Re: AER draft 2020 annual benchmarking report

CitiPower, Powercor and United Energy welcome the opportunity to provide feedback on the Australian Energy Regulator's (AER) draft 2020 annual benchmarking report.

Figure 1: Weight assigned to random energy variable

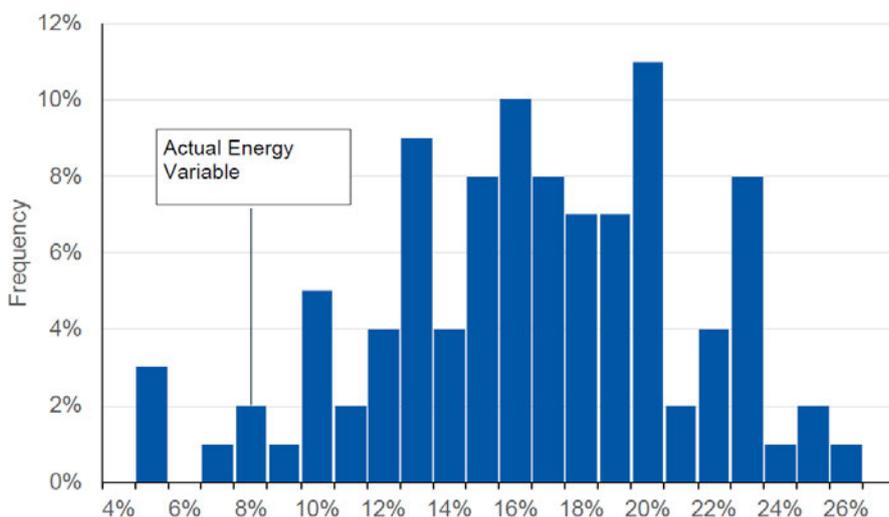
Secondly, NERA remove the energy variable as reported by a company and replaced it with a random number generated based on the mean and standard deviation of each company’s actual energy value. In effect, this randomly generated variable resembles each company’s energy variable in level and distribution but without any relation to cost in each year because random variations in it could not possibly explain variations in cost. NERA replicate this analysis 100 times and report weights resulting from each simulation in the figure below.

As the figure shows, the output weight assigned to this random variable is larger than the weight assigned to the actual energy in 95% of cases, even though it clearly bears no relation to variations in cost. This suggests that energy is no stronger a driver of cost than a random number with a similar average level.

In fact, all of the spurious data series above (including the randomly-generated energy variables above) have one key feature in common: they all exhibit similar levels of variation relative to their mean levels. Due to the restrictions of the econometric specification (non-negative coefficients and no constant), most regressions only have one variable with only one non-zero output coefficients. Therefore, a variable with any negative values or

Figure 3: Output weights vary with regression specifications

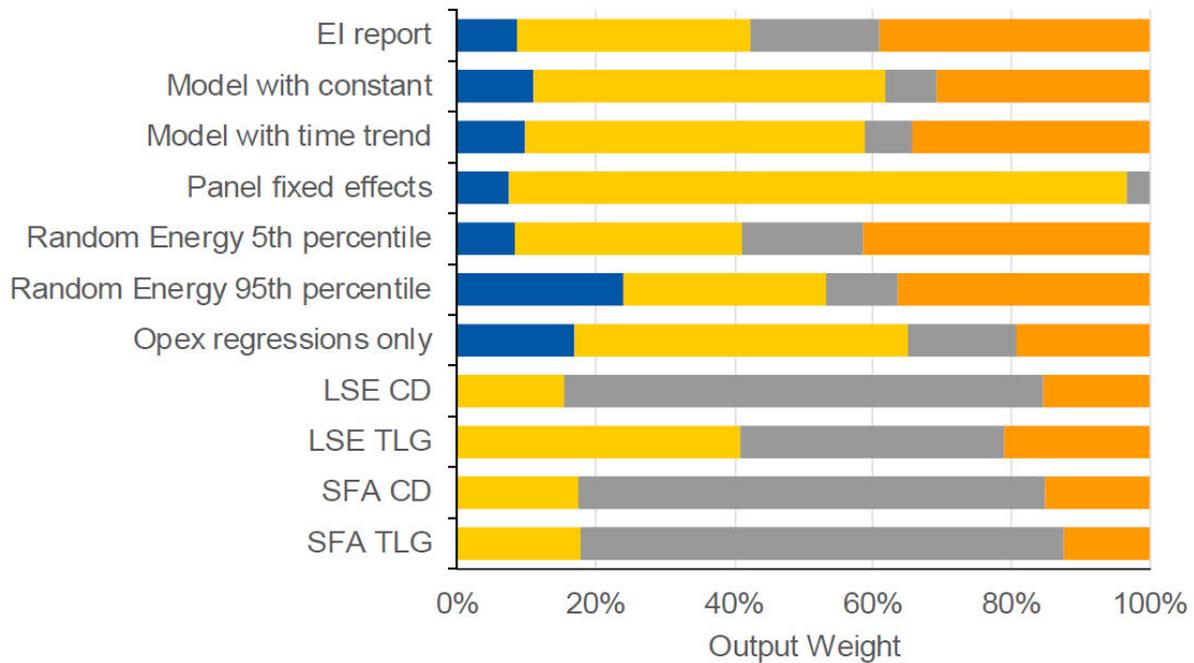
The weights allocated to each of the four outputs depend on the regression specification used. In figure 3, NERA demonstrate the sensitivity of the ultimate weights to each of the alternative econometric specifications discussed above, as well as the 5th and 95th percentile iterations (in terms of weight on energy) from the random energy simulation above. NERA also show the weights from the cost functions for comparison.

The sensitivity of the output weights to the regression specification is clear. The output weight allocated to energy is halved when moving from the EI model to the panel fixed effects model. The weight allocated to customer numbers shrinks to less than a third of its previous value in all alternative specifications. In the EI model, circuit length is the greatest contributor to output costs; in all alternative specifications, demand is the greatest contributor.

Overall, this analysis illustrates that the output weights derived from the Leontief regressions are not reliable because they are volatile and precarious to changes in model specification. Alternative, more plausible specifications of the regressions yield very different weights.

Figure 4: Annual operating expenditure efficiency scores using SFA CD cost function

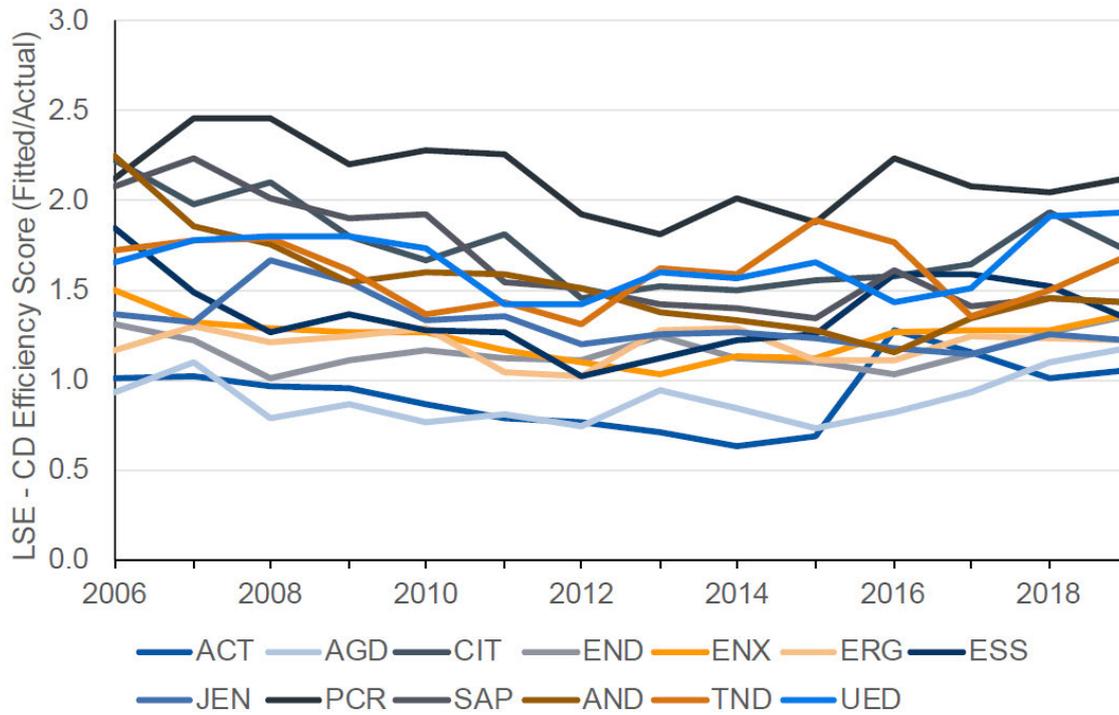
The AER annual benchmarking reports rely upon analysis of the MPFP model prepared by EI, including analysis of companies’ year-on-year changes in efficiency as well assess the drivers of annual efficiency changes. Whilst EI has not set up the econometric cost function models to present the same analysis, it is simple to do. To demonstrate, NERA has prepared figures 4 and 5 efficiency scores from LSE-CD econometric model.

Figure 4 shows each company’s efficiency relative to its peers on an annual basis, and also relative to itself in previous years, based on the LSE-CD model.
